SOUTH CAROLINA ELECTRIC & GAS COMPANY REVISION SUMMARY		PAGE 2 OF 21
CALCULATION NO. DC03050-001		
<u>REV NO.</u> 0	<u>SUMMARY DESCRIPTION</u> This calculation identifies the predicted forces and acceptance criteria for the RB horizontal and dome tendons that were selected for the fifth period surveillance and the adjacent tendons.	
<input type="checkbox"/> CONTINUES ON PAGE

Project Title RB Horizontal & Dome Tendon Force

VERIFIER'S COMMENTS

SUBJECT CODE 305		SOUTH CAROLINA ELECTRIC AND GAS COMPANY CALCULATION RECORD			PAGE 1054
CALC TITLE CORRECTED 95% BASE PREDICTION FOR 43BA		CALC NO. DC03050-001		REV 1	STAT A RBL 1/18/96
PARENT DOCUMENT STP0160.001		SYSTEM BS		SAFETY CLASS NN QR SR	
ORIGINATOR PARSONS, G. P.	DISC CS	ORGANIZATION SCE&G DE	DATE 1/18/96	XREF NO. DC03050-001

Figure 2-1 Dome Tendons Force-Time Curve
(Average Of Normalized Surveillance Forces)

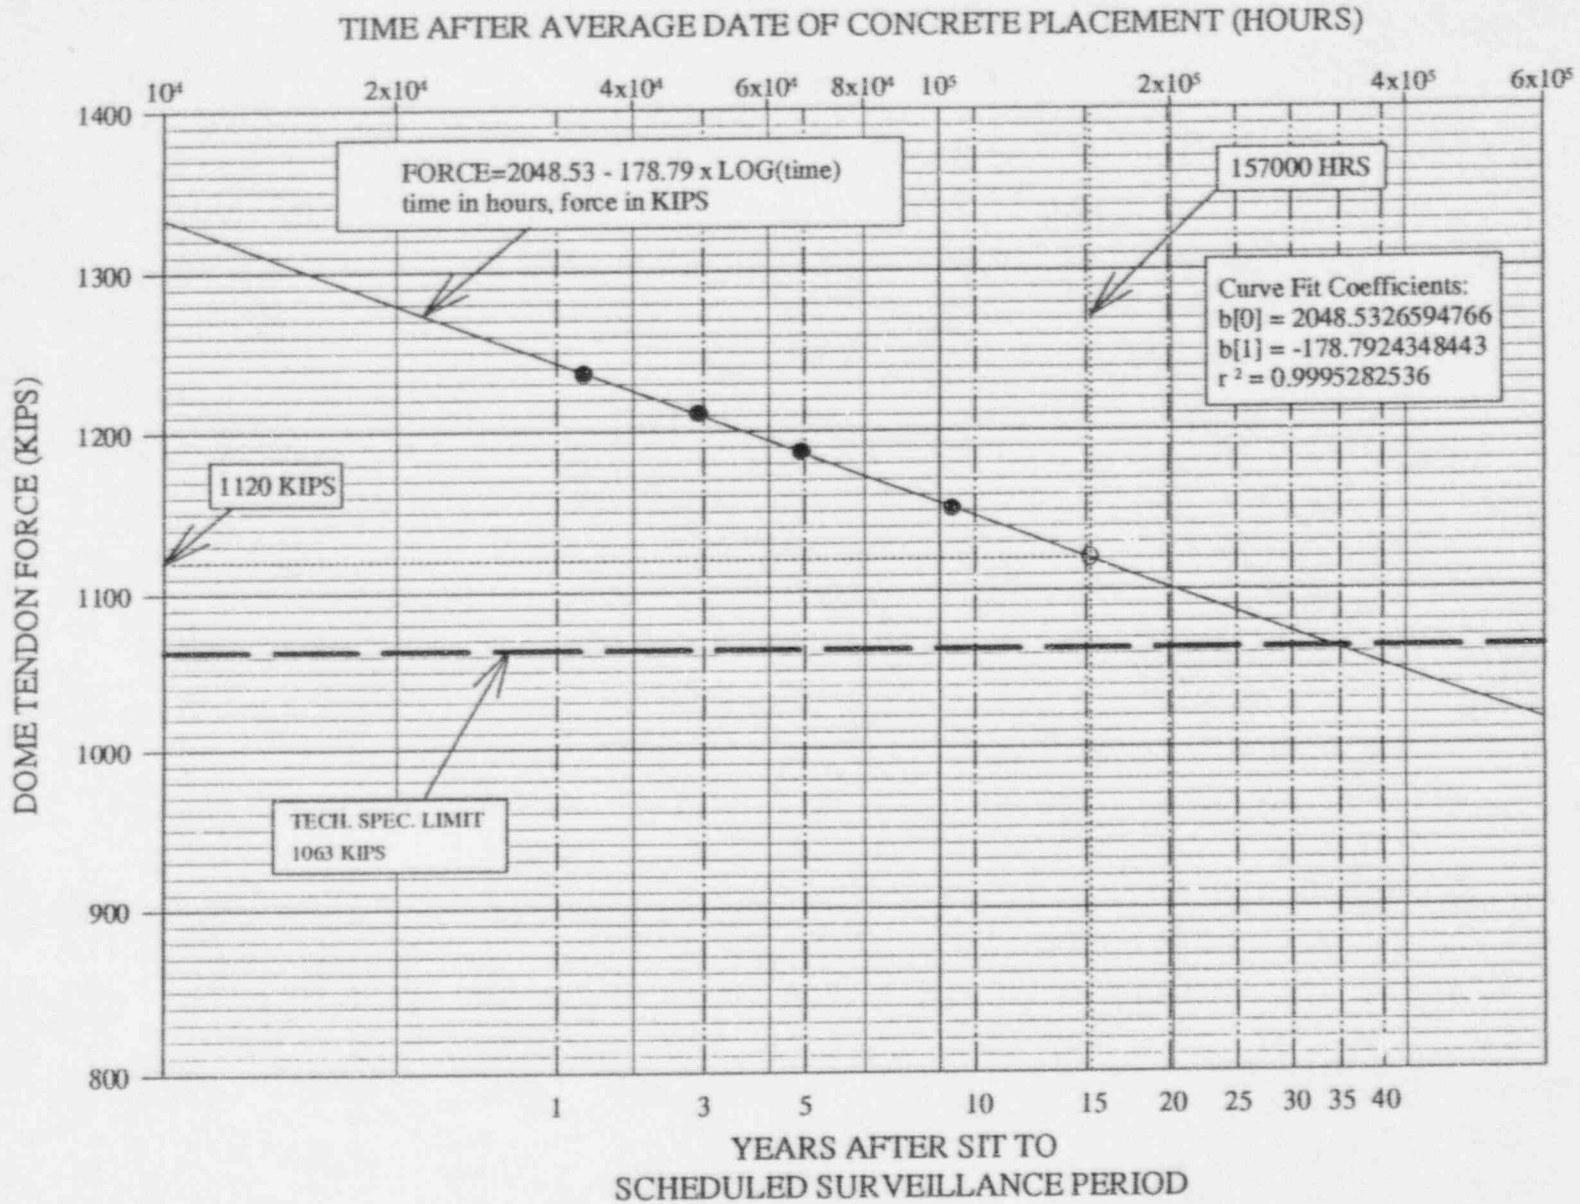
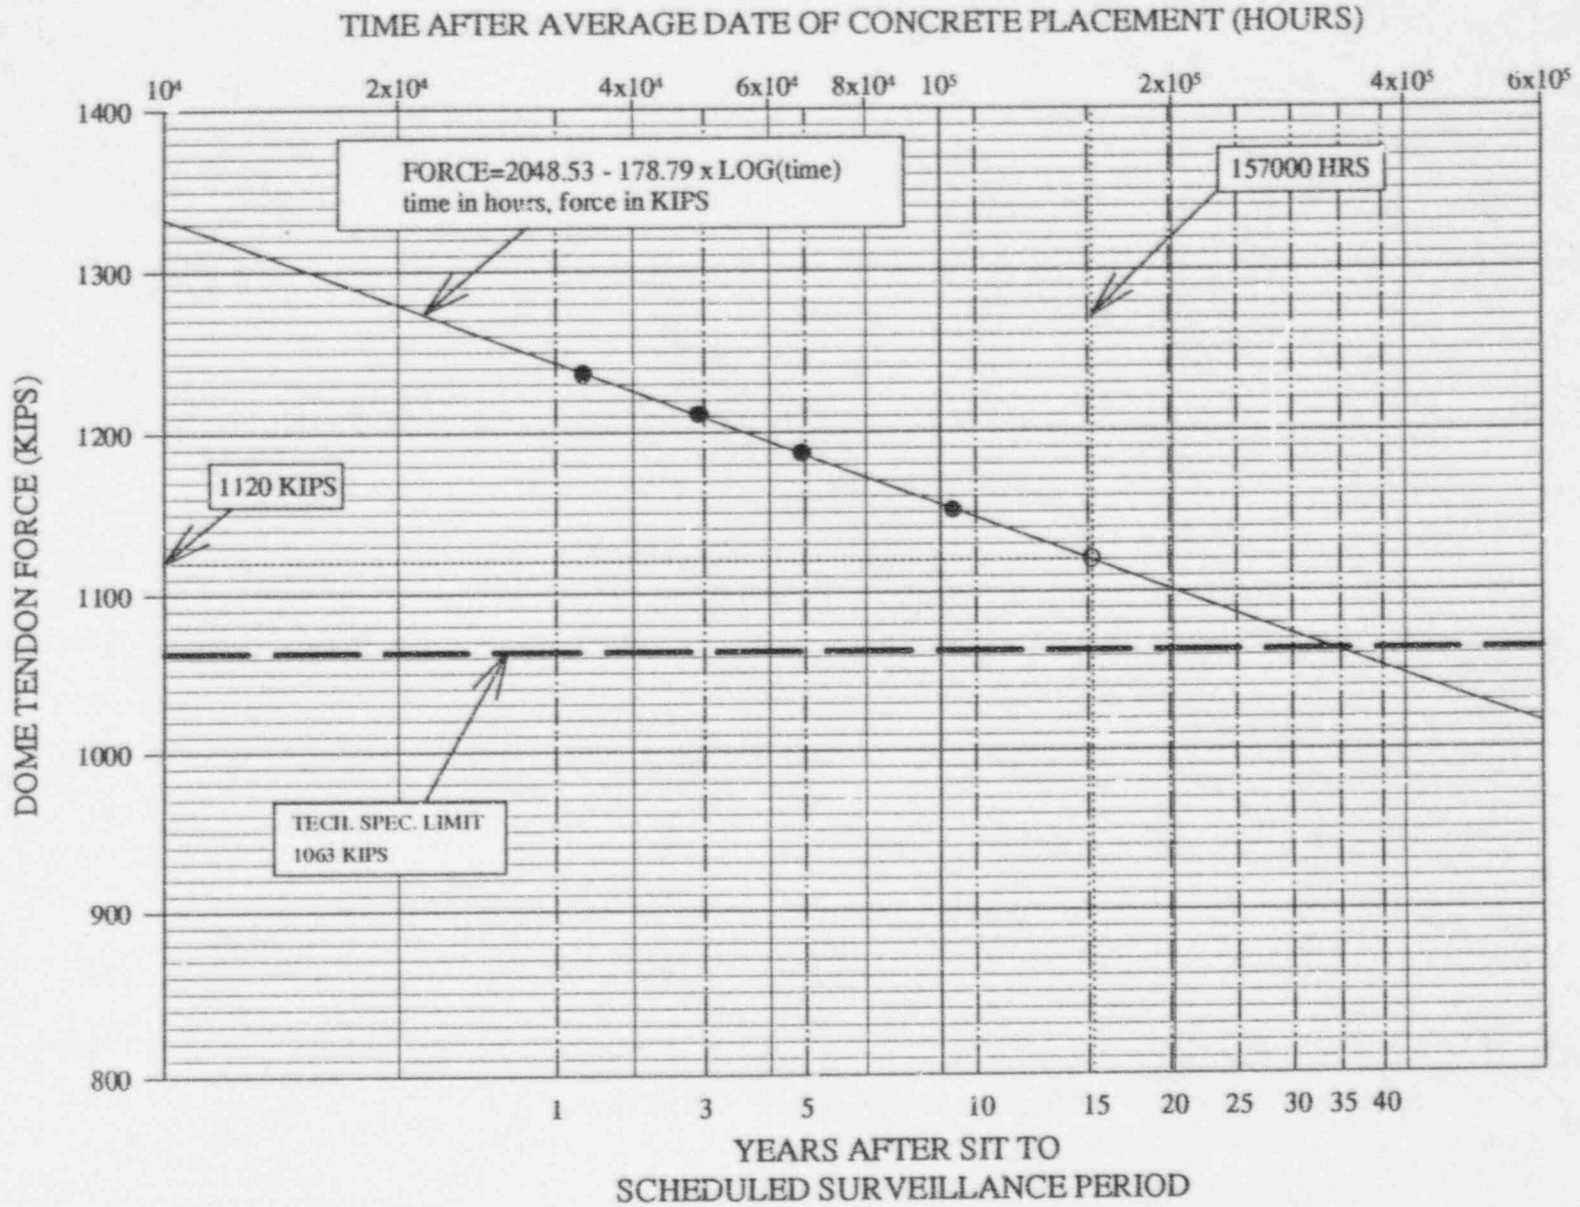
Previous tendon force predictions were based on subtracting a series of estimated force loss factors from the original lock-off force value. This calculation method replaces these estimated values with graphically derived values. The graphically derived values are extrapolated from previous surveillance data. This is a more accurate way of deriving the predicted forces since it more accurately defines the unknowns affecting these particular tendons. The calculation inputs include time of original lock-off, original lock-off force, Normalization factors ect.. These values were obtained from previously verified documents and are reasonable and accurate for this application. The primary assumption in this calculation is that if the tendon force vs time is plotted on a semi-log plot, the data points will form a straight line. This assumption is reasonable and is shown to be accurate based on previous tendon force data.
